TRANS/WP.29/2002/34  
11 April 2002

PROPOSAL FOR DRAFT SUPPLEMENT 2 TO THE 01 SERIES  
OF AMENDMENTS TO REGULATION No. 94

(Frontal collision protection)

Transmitted by the Working Party on Passive Safety (GRSP)

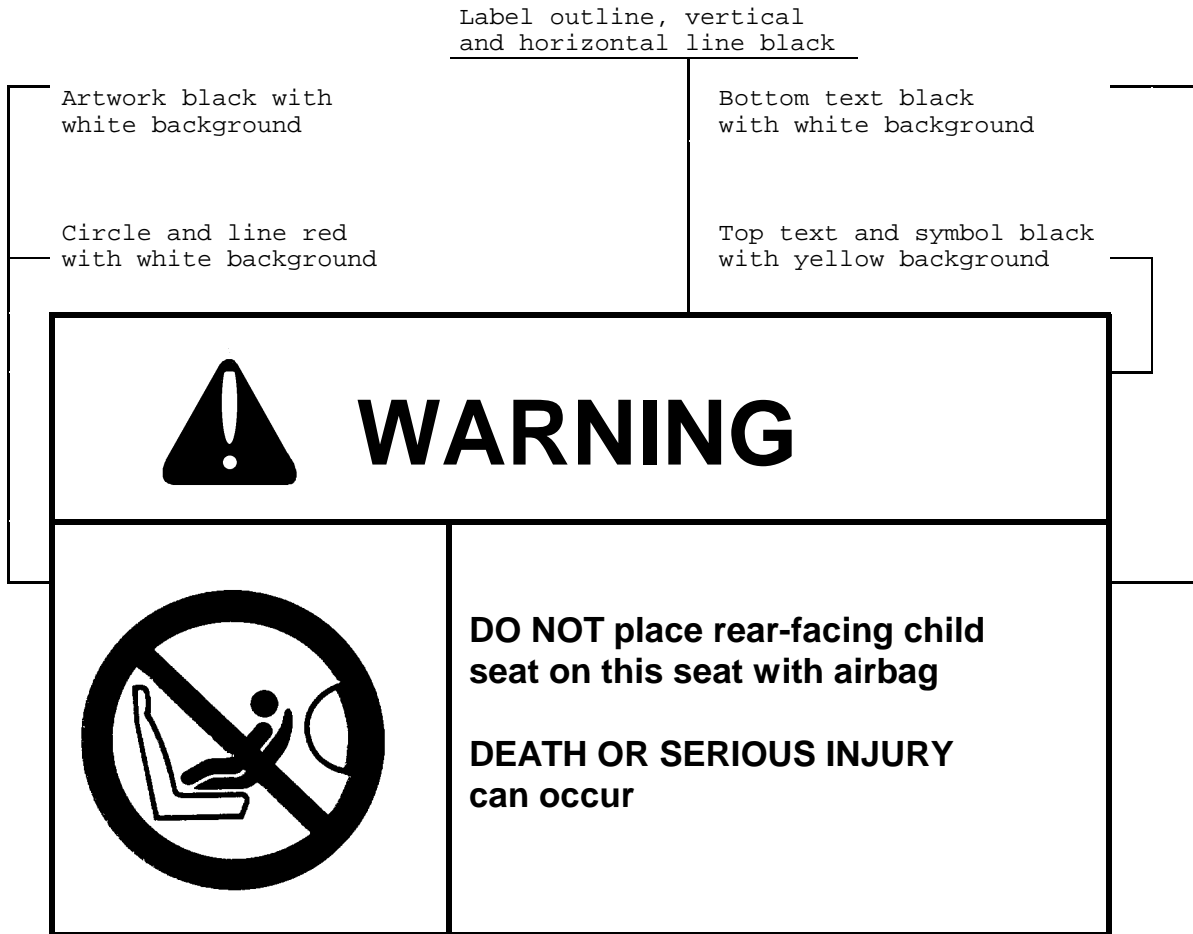
Paragraphs 6.1.2. to 6.2.3., amend to read:

"6.1.2. For a vehicle fitted with a passenger airbag intended to protect occupants other than the driver, this information shall consist of the warning label described in paragraph 6.2. below.

6.2. A vehicle fitted with one or more passenger frontal protection airbags shall carry information about the extreme hazard associated with the use of rearward-facing child restraints on seats equipped with airbag assemblies.

6.2.1. As a minimum, this information shall consist of a label containing a pictogram and text warning as indicated below.

The overall dimensions shall be 120 x 60 mm or the equivalent area, as a minimum.

The label shown above may be adapted in such a way that the layout differs from the example above; however, the text content shall meet the above prescriptions.
